Glenmore Trail East Interchanges Functional Planning Study

Appendix H - Road Safety Audit Report

Glenmore Trail: 100 Street SE to Rainbow Road Road Safety Audit

Glenmore Trail - 100 Street SE to Rainbow Road Interchange Functional Plan Road Safety Audit

PLAN RP1

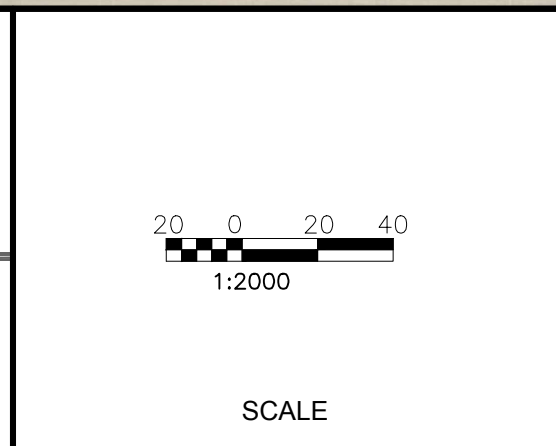
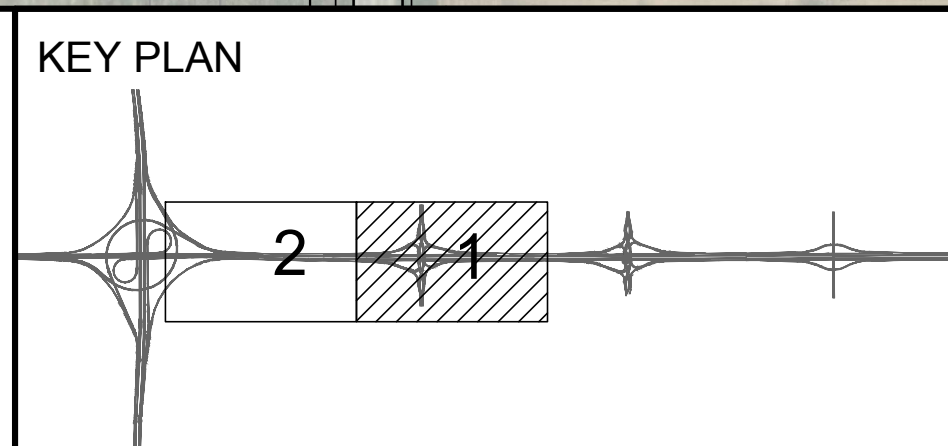
Issue 2	Inadequate Weave and Decision Sight Distance	
Description	<p>For the basket weave option at 100 Street SE, there is a very short weave for SB-WB and NB to Stoney Trail traffic. The short weaving distance may result in sideswipe and rear-end collisions. The risk is amplified by the likely high traffic volumes (particularly trucks) and limited sight distance due to the horizontal curves on both approaches. Furthermore, there is not adequate distance to provide guidance (through guide signs) to motorists at the fork due to the close proximity to 100 Street SE.</p>	
Location(s)	<p>Weaving section in northwest quadrant of 100 Street SE interchange.</p>

Issue 4		Offset Stop Lines	
Description	<p>The stop bars at the cross-over intersections at the 100 Street SE interchange appear to have significant offsets. This, may result in motorists in the left-hand lanes encroaching into the opposing through lanes if they align with adjacent vehicles rather than the stop bar, particularly if the stop bar is deteriorated or covered in snow. It is noted that pavement markings are not developed at this stage and may not be the intended location for the stop bars, but the comment is still provided for consideration.</p>		
Location(s)	<p>Stop bars at the cross-over intersections at 100 Street SE</p>

Issue 10 Pedestrian Crosswalks on High Speed Ramps							
Description	<p>The pedestrian cross-walks on the NB to EB and SB to WB ramps at the 100 Street interchange are located mid way down the ramps. At this location, motorists may already be accelerating as they approach the mainline. Furthermore, they may not anticipate pedestrians so far down the ramp. Both of these factors may reduce motorists' ability to stop in the event of a pedestrian crossing.</p>						
Location(s)	<p>NB to EB and SB to WB ramps at the 100 Street interchange.</p>						
Drawing(s)	 <p>Plans: RP1, PP2</p>						
Risk Assessment

Issue 13	Close Proximity of Exit Ramps	
Description	<p>The exit ramps on westbound Glenmore Trail for 100 Street SE and Stoney Trail are in close proximity (380m) in the basket weave option. This limits the decision sight distance available to inform motorists of the exit locations. Providing adequate guide signage could be a challenge. With limited decision sight distance, there is an increased risk of erratic driver behaviors and abrupt lane changes that may potentially result in sideswipe and rear-end collisions.</p>	
Location(s)	<p>WB Glenmore Trail off-ramp to NB 100 Street SE and Stoney Trail.</p>

Drawing(s)	 <p>Plan: RP1</p>	
Risk Assessment	<p>Expected Severity:</p>	<p>PDO – Minor Injury</p>
	<p>Expected Frequency:</p>	<p>> 5 per year</p>
	<p>Risk Rating:</p>	<p>C - D</p>
Mitigation Suggestions	<ul style="list-style-type: none"> • Increase the length of the weaving section • Relocate the weave further west of intersection • Consider alternate basket weave or interchange configuration

Drawing(s)	 <p>Plans: RP1, PP2</p>		
Risk Assessment	Expected Severity:	Major Injury - Fatal	
	Expected Frequency:	<p>< 1 per year, > 1 per 5 years</p>	
	Risk Rating:	C - D	
Mitigation Suggestions	<ul style="list-style-type: none"> Align stop bars with the stop bar furthest from the intersection. Ensure signal timings and clearance provide sufficient yellow and red times to clear the intersection.

Expected Severity:	Major Injury	Expected Frequency:	< 1 per 5 years	Risk Rating:	B
Expected Severity:	Major Injury						
Expected Frequency:	< 1 per 5 years						
Risk Rating:	B						
Mitigation Suggestions	<p>Consider relocating the pedestrian crosswalks further upstream, closer to the slower speed cross-street, where operating speeds are likely lower and motorists are more likely to anticipate pedestrians.</p>

Drawing(s)	 <p>Plan: RP1</p>	
Risk Assessment	<p>Expected Severity:</p>	<p>Property Damage Only</p>
	<p>Expected Frequency:</p>	<p>1 – 4 per year</p>
	<p>Risk Rating:</p>	<p>B</p>
Mitigation Suggestions	<ul style="list-style-type: none"> • Increase separation distance between interchange off-ramps
